December 5, 2022

Dan Reinhard  
Senior Project Manager, Location and Design  
Virginia Department of Transportation

Enclosed please find Arlington County staff comments on the VDOT Route 1 Multimodal Improvements Study Phase 2 details presented to date. We appreciate the opportunity to provide a thorough review of how the VDOT Route 1 Concept Plan and streetscape alternatives align with the Crystal City Sector Plan (CCSP), other Board-adopted plans and policies, and ongoing projects and private development nearby.

## **Arlington County Comments on VDOT Route 1 Multimodal Improvements Study Phase 2**

Figure 1. Recommended cross-section from 23<sup>rd</sup> Street to 18<sup>th</sup> Street.

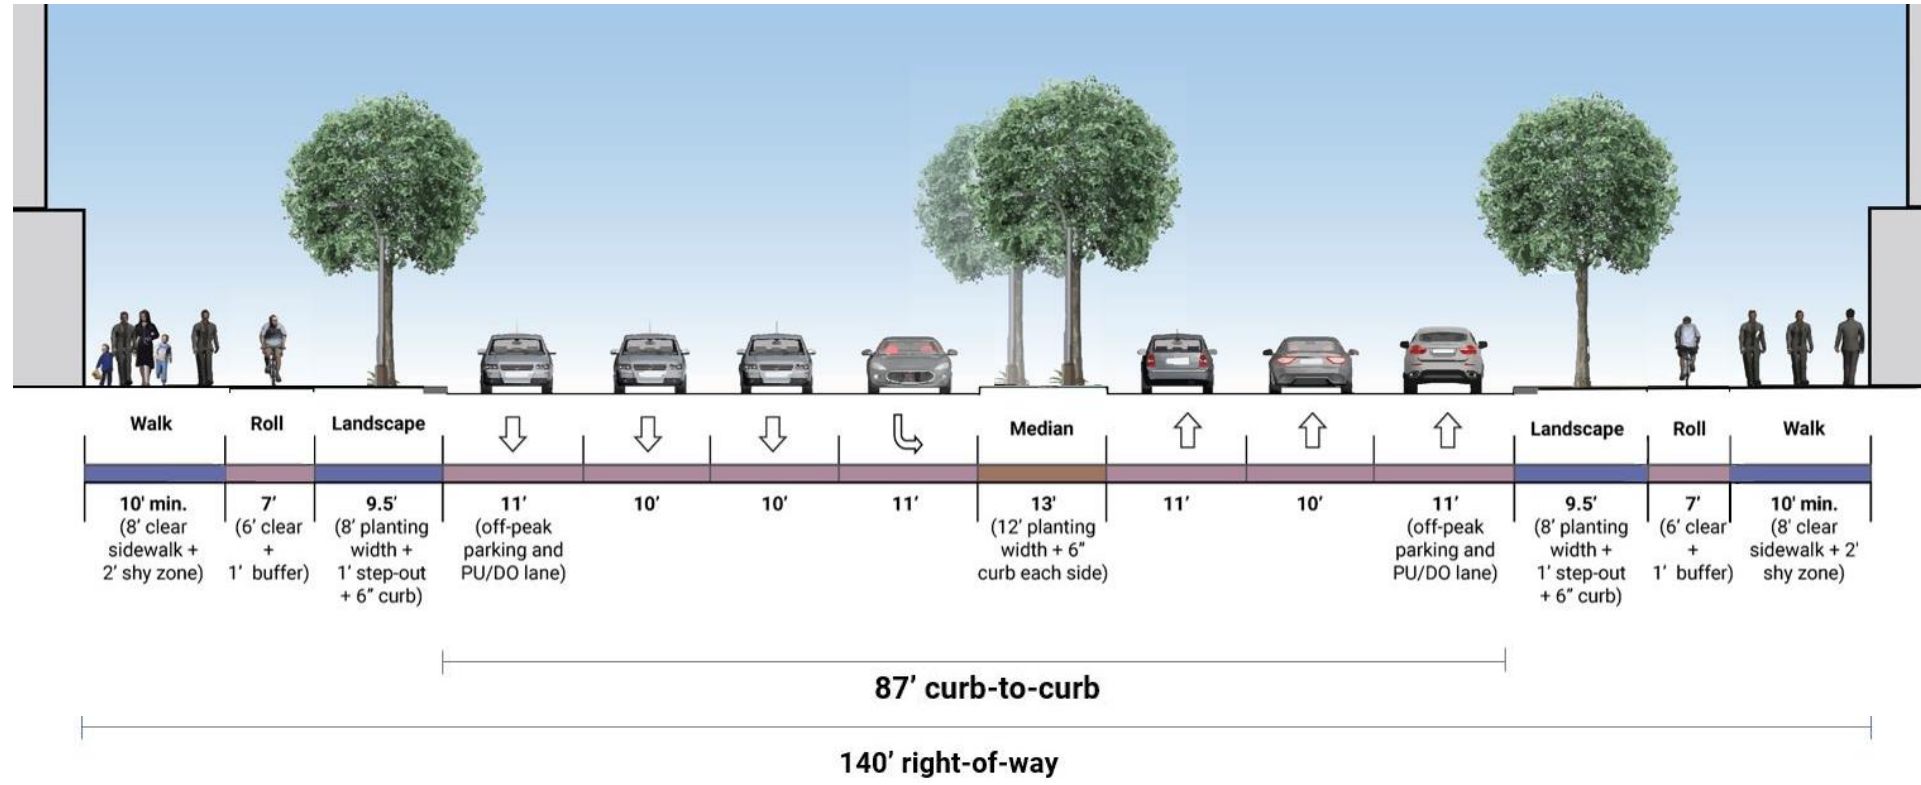
- a. Follow the right-of-way recommendations outlined in the CCSP, which account for right-of-way constraints and development patterns south of 18<sup>th</sup> Street and wider available right-of-way north of 18<sup>th</sup> Street:

- a. 140' from 23rd Street to 18th Street and
  - b. Up to 160' north of 18<sup>th</sup> Street, to accomplish minimum recommendations described in the following sections.
- b. Maintain a consistent curb-to-curb width of 87 feet from 12th Street to 23rd Street, as shown in Figures 1 and 2, with the remaining width dedicated to streetscape elements behind the curb. North of 18<sup>th</sup> Street, use the additional width to provide the wider cross-section shown in Figure 2. This is feasible without impacting the land development potential to the east and northwest of Route 1 at 15<sup>th</sup> Street, as envisioned in the Sector Plan.

Figure 2. Recommended cross section from 18<sup>th</sup> Street to the north.

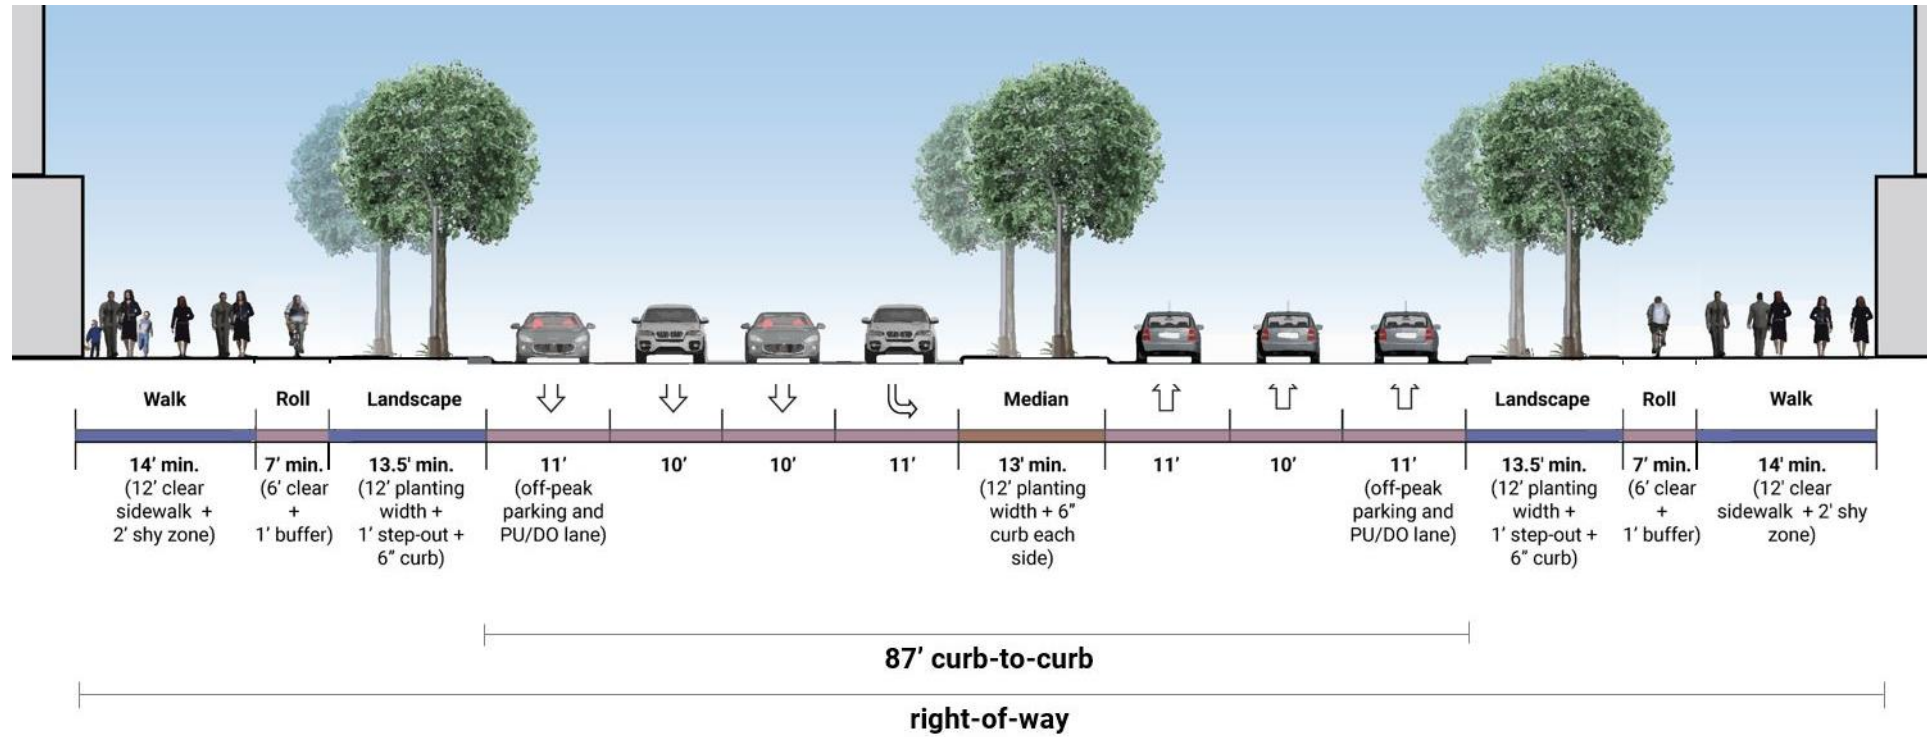
Consistent with this guidance, County staff recommend a cycle track similar to VDOT’s Streetscape Option 3, with the cycle track placed between the landscape zone and sidewalk clear zone similar to VDOT’s Streetscape Option 4 (see Figures 1 and 2). A 1-foot buffer should be provided between cycle track and sidewalk. Combined with the other recommendations in this memo, it is feasible to provide a bicycle facility along Route 1 while still meeting or exceeding the minimum recommended widths of other streetscape elements.

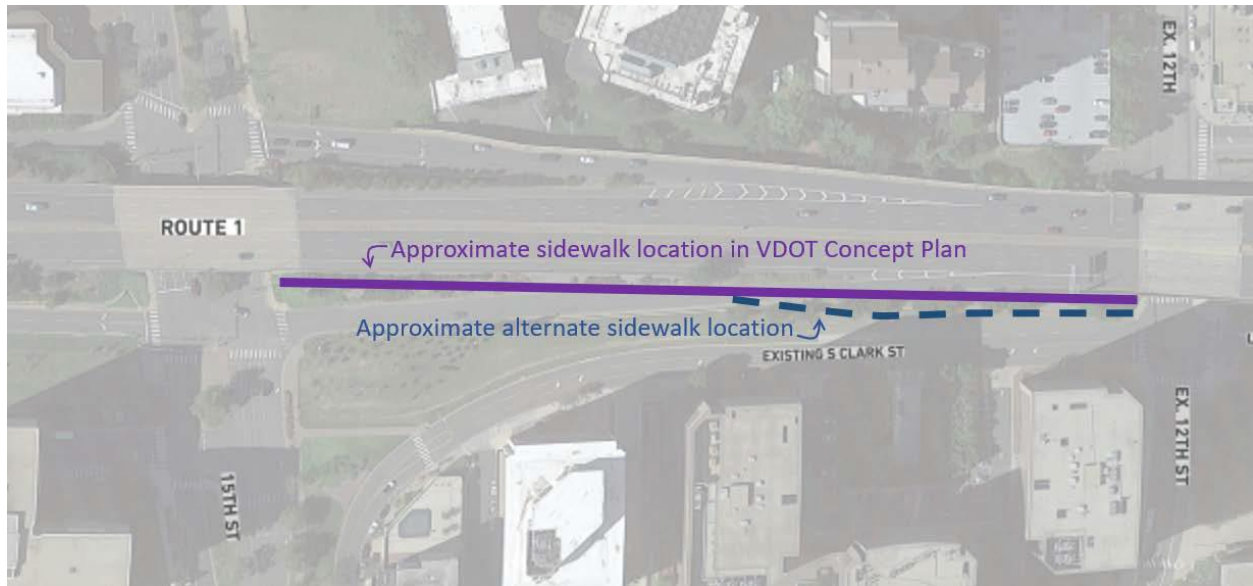
The VDOT Concept Plan includes 11-foot travel lanes with an additional 1 ½-foot wide gutter pan on the outside travel lanes. Travel lane width directly influences crossing distances for pedestrians (and thus exposure) and can also influence driving speeds. On retrofit projects in urban areas, lane widths also influence how much space is available for streetscape/pedestrian elements located outside of the curbs. The AASHTO Green Book specifies that lane widths on urban arterial roadways can vary from 10 to 12 feet. AASHTO does not have requirements for the gutter pan. Some state Departments of Transportation do not use gutter pans while others permit them within the outer lane dimension. Arlington County's practice is to use gutter pans but include it as part of the outside lane width.

- a. Minimize travel lane widths to align with the Crystal City Multimodal Transportation Study and the Arlington County Pavement Marking Specifications:
  - o 10 feet for inside lanes
  - o 11 feet for outside lanes and turn lanes, inclusive of a 1.5-foot-wide gutter pan

Figure 5a. VDOT’s median cap design at the intersections of Route 1 and 20th and 15th Streets.

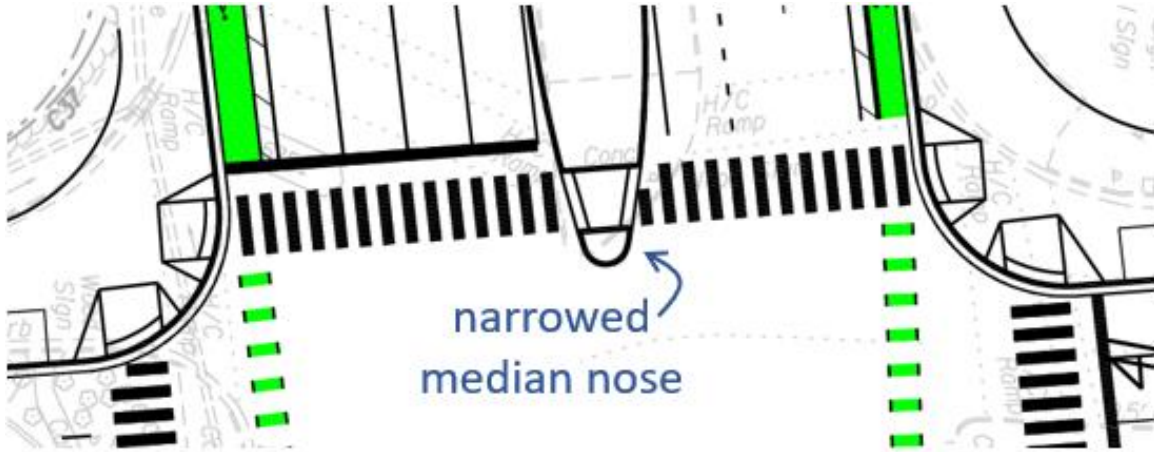
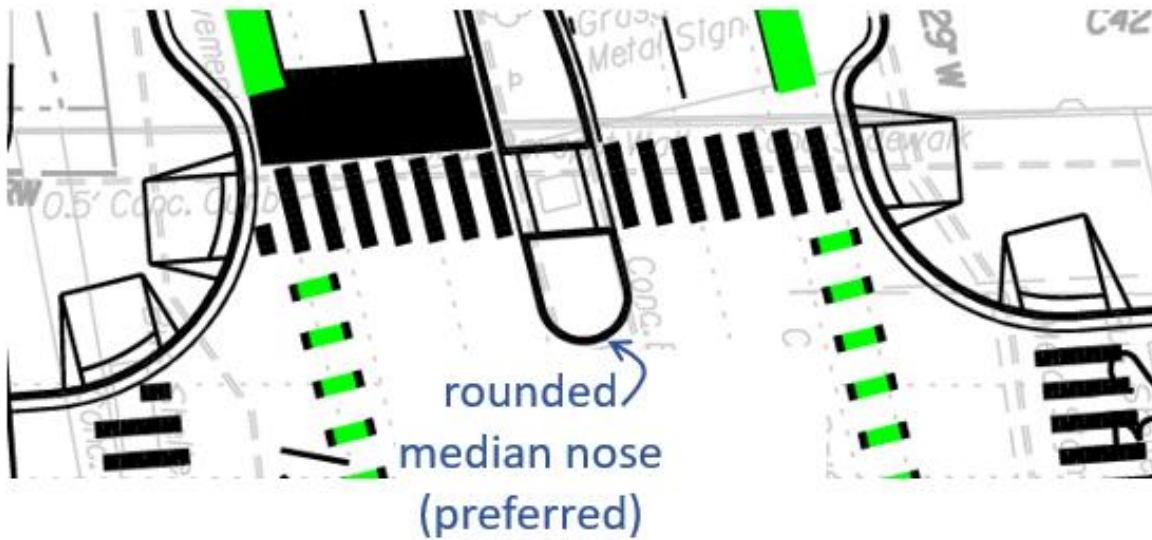
- f. Include rounded median noses at all intersections. The current VDOT Concept Design Plan shows narrowed median noses at the intersections of Route 1 and 20th Street as well as at 15th Street. The design should use Arlington County's Guidelines for the Design and Treatment of Median Noses (Version 1, 2019). With three receiving lanes for turning vehicles, narrowed medians are not necessary to accommodate turning vehicles. As described in the County's guidelines, wider median noses (as shown in Figure 5) provide a better sense of enclosure for pedestrians crossing the street and help to position turning vehicles at closer to a 90-degree angle to the crosswalk, which gives the drivers a better view of the crosswalk.

Figure 5b: Preferred design for all intersections.
